APPLICATION FOR PERMISSION UNDER SECTION 16 OF THE TOWN PLANNING ORDINANCE (CAP. 131)

For Official Use Only 請勿填寫此欄	Application No. 申請編號	A/YL-PH/1089
	Date Received 收到日期	2025 -10- 0 3

3.	Application Site 申請地點	
(a)	Full address / location / demarcation district and lot number (if applicable) 詳細地址/地點/丈量約份及地段號碼(如適用)	LOTS 9 (PART) AND 10 (PART) IN D.D. 111 PAT HEUNG, YUEN LONG
(b)	Site area and/or gross floor area involved 涉及的地盤面積及/或總樓面面積	☑Site area 地盤面積 1910 sq.m 平方米□About 約 ☑Gross floor area 總樓面面積 245.58 sq.m 平方米□About 約
(c)	Area of Government land included (if any) 所包括的政府土地面積(倘有)	N.A. sq.m 平方米 □About 約

(d) Approved use/development 已批給許可的用途/發展	RENEWAL OF PLANNING APPROVAL FOR TEMPORARY OPEN STORAGE OF VEHICLES AND LANDSCAPE PLANT MATERIALS FOR A PERIOD OF THREE YEARS

Photographic record of the drainage facilities on 27/08/2025

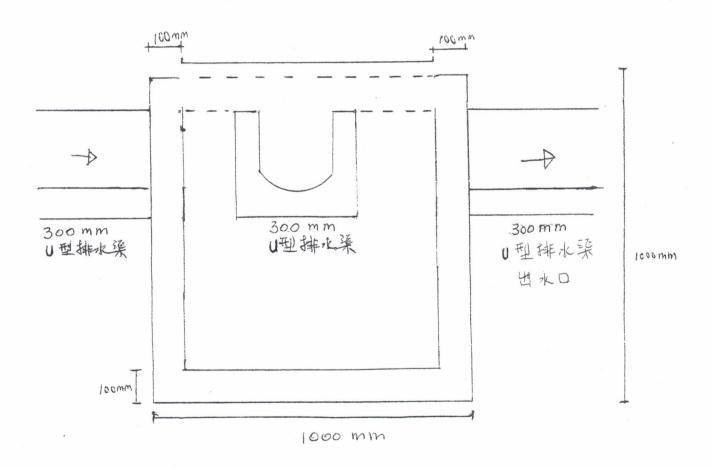
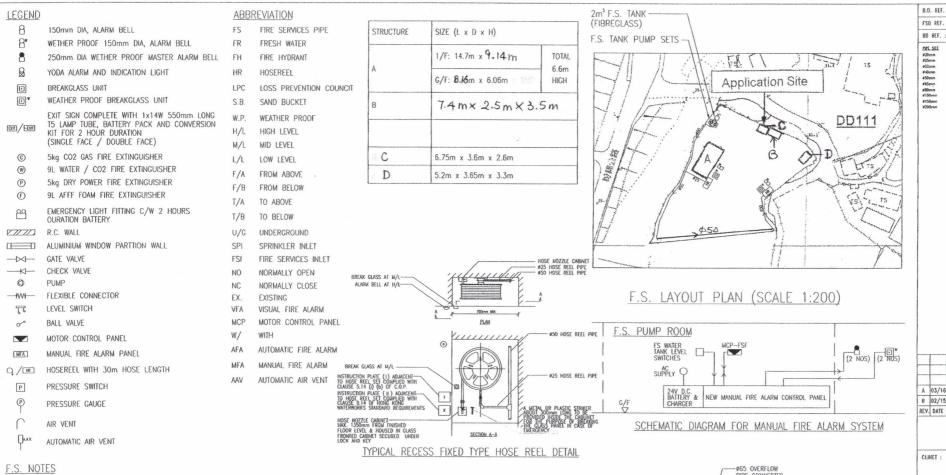
Comments of the Chief Engineer/Mainland North, Drainage Services Department:

- no adverse comment to the application from public drainage point of view;
- the submitted drainage proposal with photo record of the implemented drainage facilities is considered acceptable. The existing drainage facilities under previous application No. A/YL-PH/932 was found satisfactory; and
- advisory comments are at **Appendix VII**.

BLOCK PLAN, NOTES, LEGEND, ABBREVIATION SCHEMATIC DIAGRAMS OF HOSEREEL SYSTEM AND MANUAL FIRE ALARM SYSTEM & F.S. LAYOUT

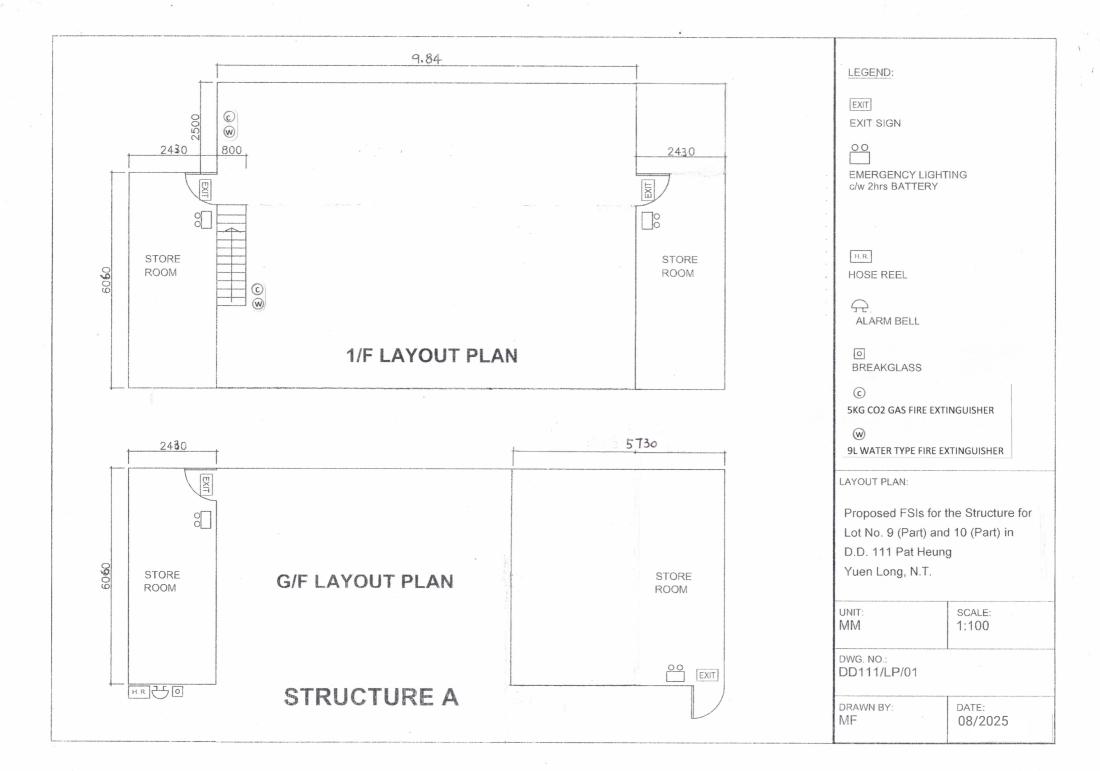
Comments of the Director of Fire Services:

- no in-principle objection to the application subject to the existing fire service installations implemented on the application site (the Site) being maintained in efficient working order at all times; and
- the submitted fire service installations proposal with fire certificates is considered acceptable.
